TECHNICAL SERVICE BULLETIN

Cup Holder Base Damaged Or Broken

25-2614

Ford 2020-2024 Explorer

Figure 1

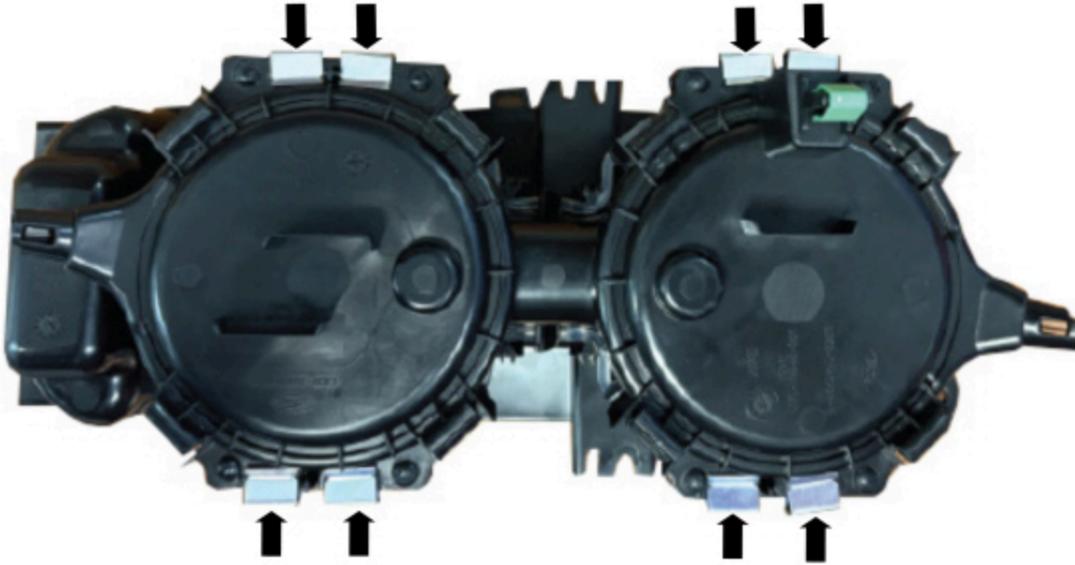
Issue: Some of the vehicles listed in the Model statement above may exhibit a cupholder base that is damaged or broken. This may be due to the heat stake clips detaching from the cup holder assembly.

1. Remove the floor console top panel. Refer to WSM, Section 307-05A Removal and Installation > Gear Shift Module > Steps 1-8.
2. Install 2 clips on each side of the cupholder base in the indicated areas. (Figures 1-2).
